PC18 - Cashmere Fields/Hendersons Basin

This is inconsistent with integrated urban design principles underpinning the RNN framework.

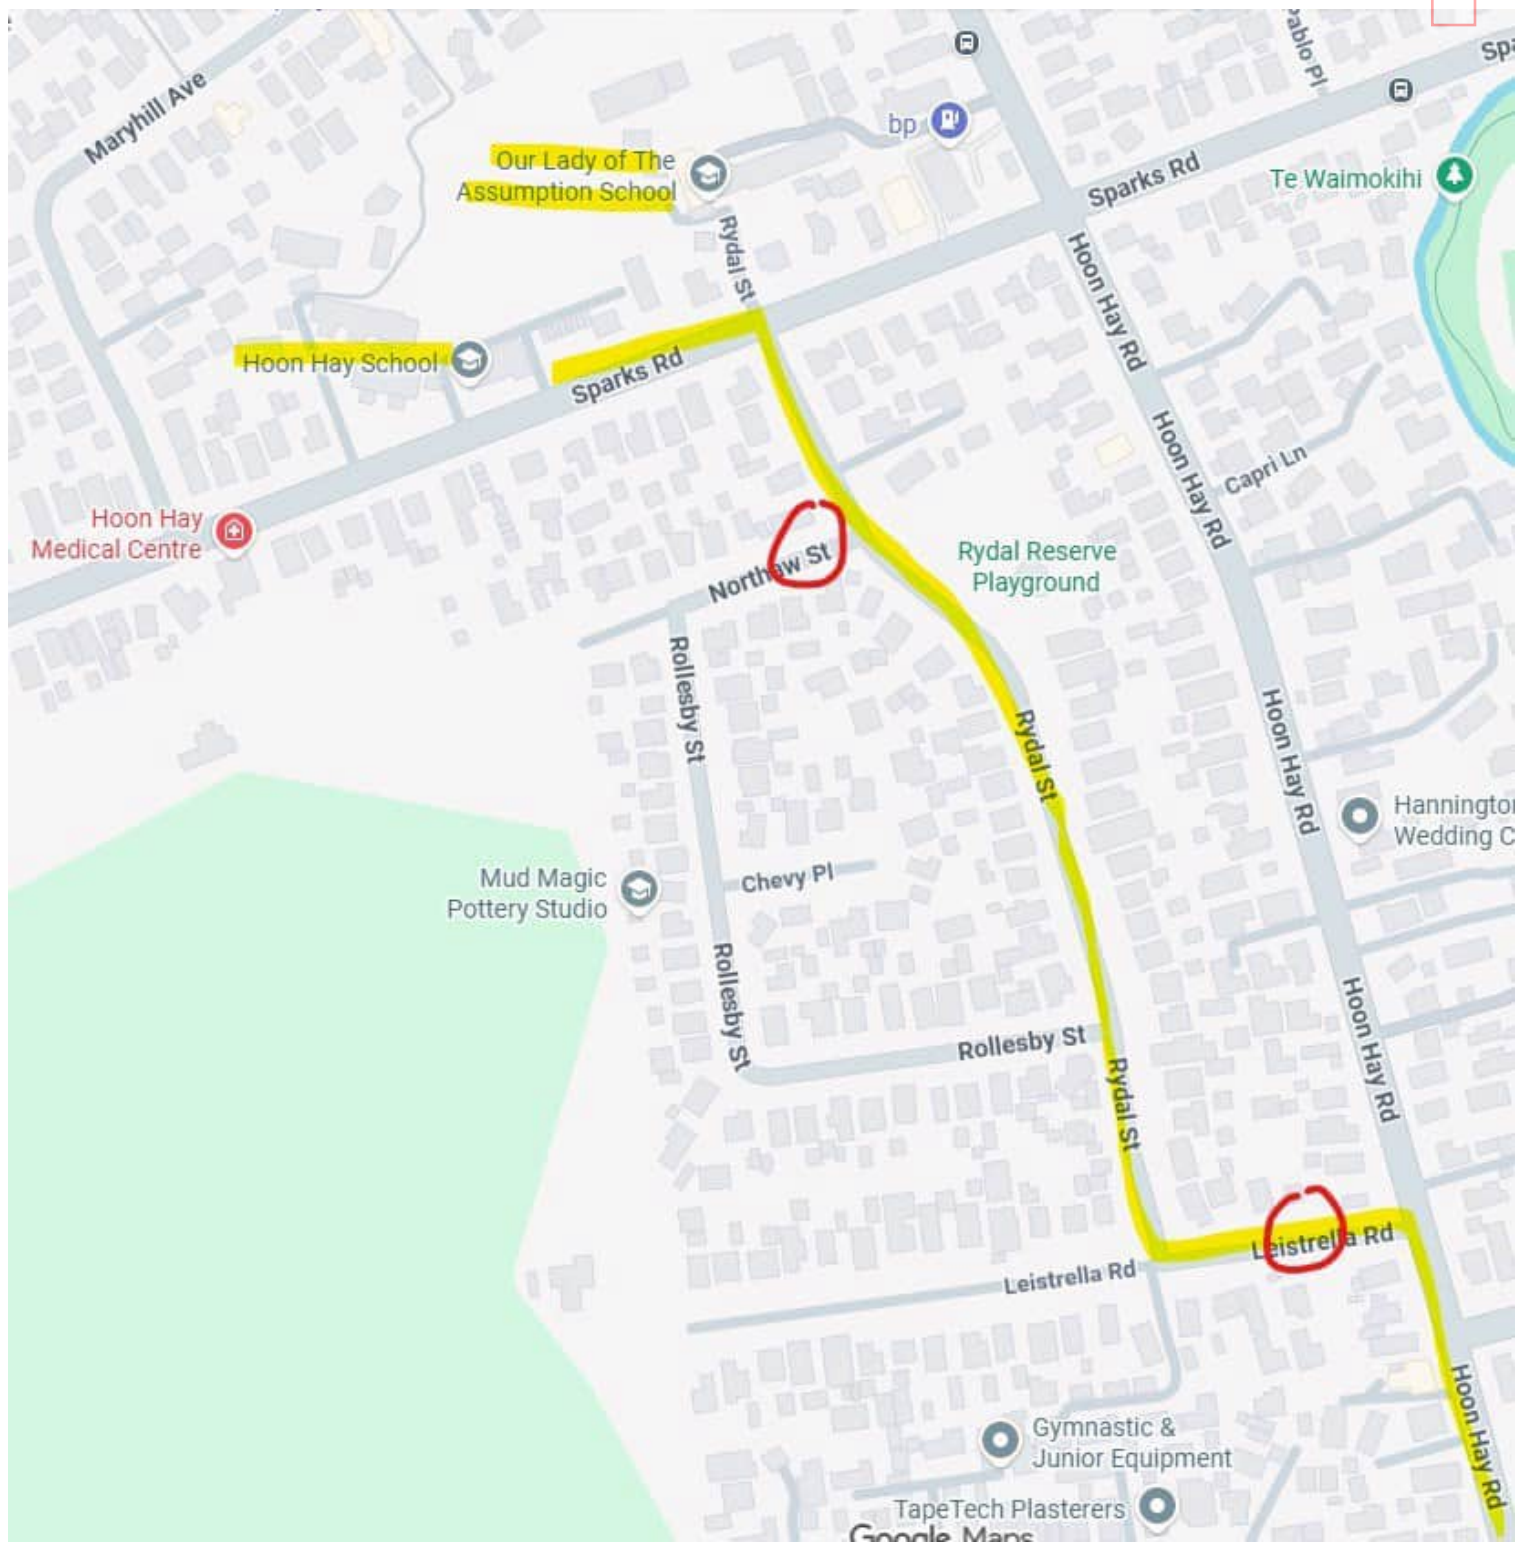
Hoon Hay Road -- Leistrella Road -- Rydal Street is a popular walking route for children attending two nearby primary schools on Sparks Road: Hoon Hay Te Kura Kōaka and Our Lady of the Assumption (yellow highlighted route on the attached supporting documentation). I am concerned about the safety of children crossing the roads due to the increased traffic volume from the new residential area.

If the rezoning plan is to be approved, scope and implement road crossing safety measures. For example, safe crossing points at the intersection of Northaw Street and Rydal Street, and on Leistrella Road between Rydal Street and Hoon Hay Road. These are circled in red on the attached supporting documentation. Both places are already busy for kids who are walking (or biking/scootering) during school pick up/drop off times as many children travelling by car are dropped off at the Sparks Road end of Rydal Street, or on Northaw Street.

Name	
Flooding on Leistrella Road

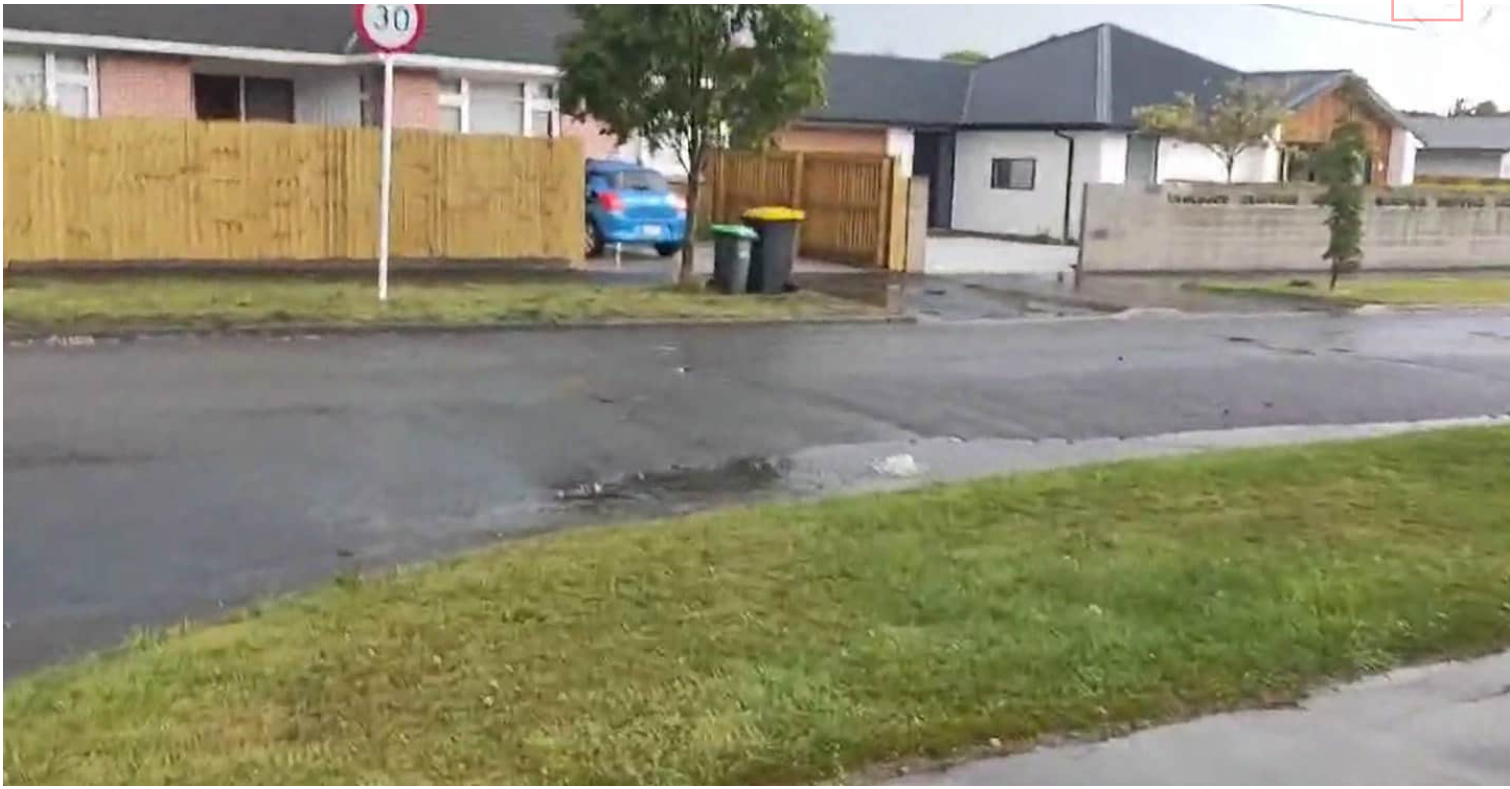
Currently, the drainage in the area cannot handle heavy rain. Adding further intensification without solving the deficiencies of the current drainage makes no sense. The drainage in the immediate area cannot handle rain numerous times a year. This is before you consider the implications downstream on the Heathcote river which floods often. Adding more concrete to a traditional flood plane area is irresponsible.

I would like the council to commit to fix the drainage in the area before approving any more development. Please note that the page will not upload my video in support of this evidence, but it was been previously sent to planchange@ccc.govt.nz at Fri 13/02/2026 7:00 pm. I would be happy to send again or provide via another means. I have instead attached a picture showing water bubbling up out of the drain on Leistrella Road.

126 Sparks Road, not mentioned in the Eliot Sinclair section of the PPC.

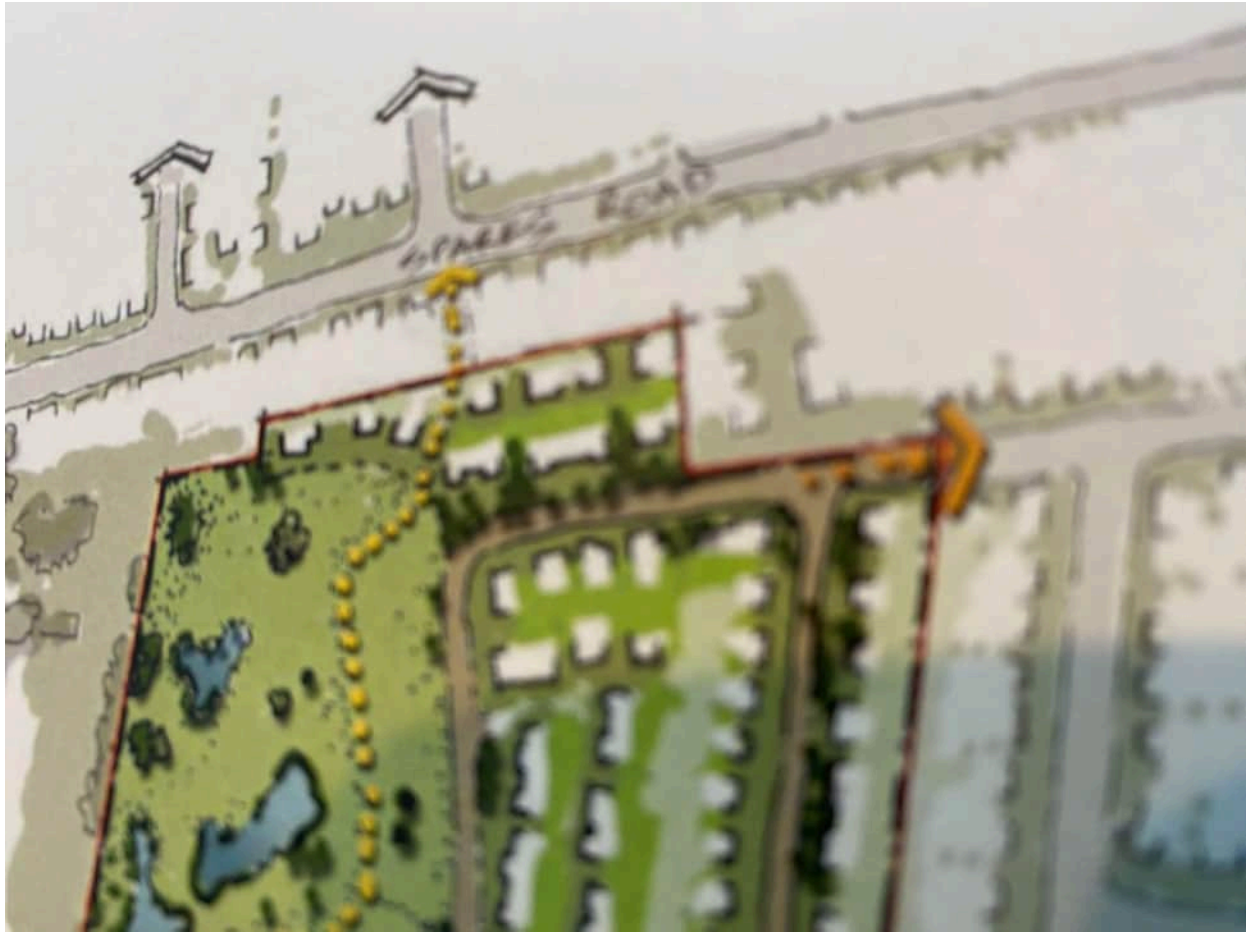
Note it is built on a substantial rise (actual rise is more discernable on site, as the grass in the foreground is currently long)

This height of foundation is necessary for flood mitigation, as this area is in the High Flood Hazard Management Area, and for minimum floor level consent requirements. According to the Geotech reports in the PPC it is “interbedded loose to very loose silts and silty sands, down to dense gravel 9-12mt below ground level. Potential for lateral spread towards stormwater basins, that will require mitigation for category TC2 or TC2/TC3 so will need TC2/TC3 hybrid type foundations. Groundwater was observed fluctuating between 2mt depth to ground level. Median water table 1.3mt below ground surface.

However, this report was done Dec 2022, before the son’s house (126 Sparks) was built. This new construction has therefore set a precedent for subsequent builds.

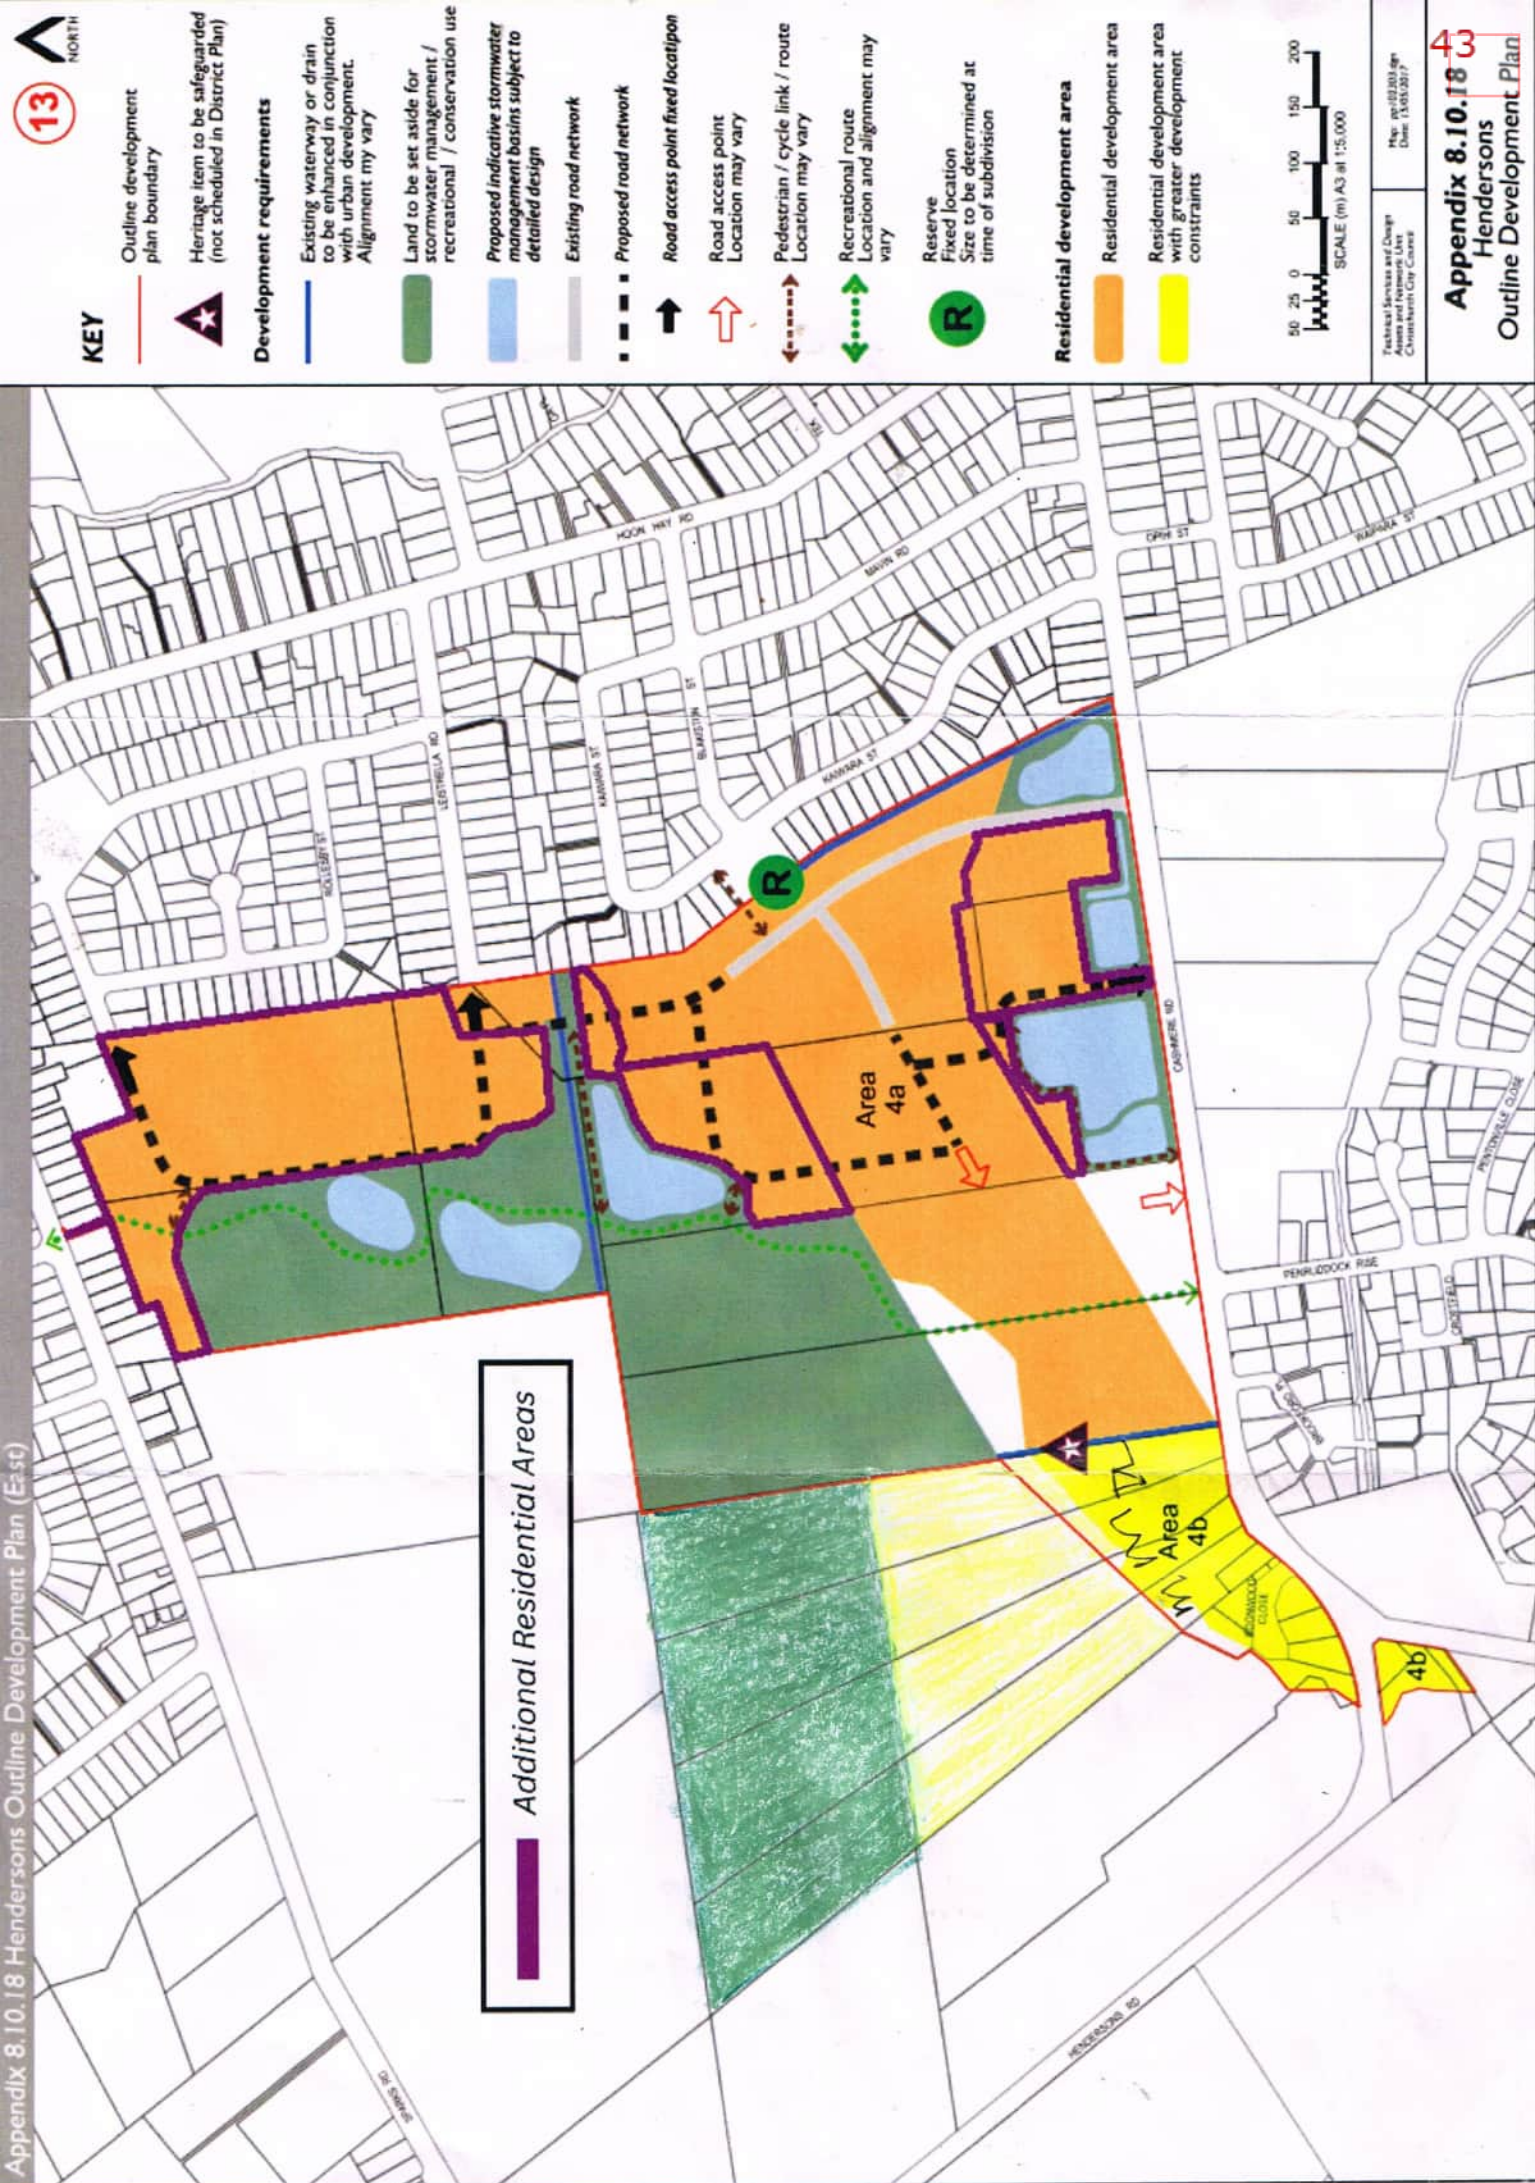
Due to time constraints we were unable to consult with our neighbours and family members to provide further details for our future development, for the areas marked in green and yellow on our plan attached.

We do not oppose to the 300 residential lots. The Council should consult all the rural land owners (Sparks, Henderson, Cashmere roads) for the future development for the whole areas to enable to supply more residential housing and green space. The Council already owns the land on the corner of Sparks and Henderson road and continuing the green space across our land to the proposed green space allows more benefits/access for recreational users. Refer to our attached plan.
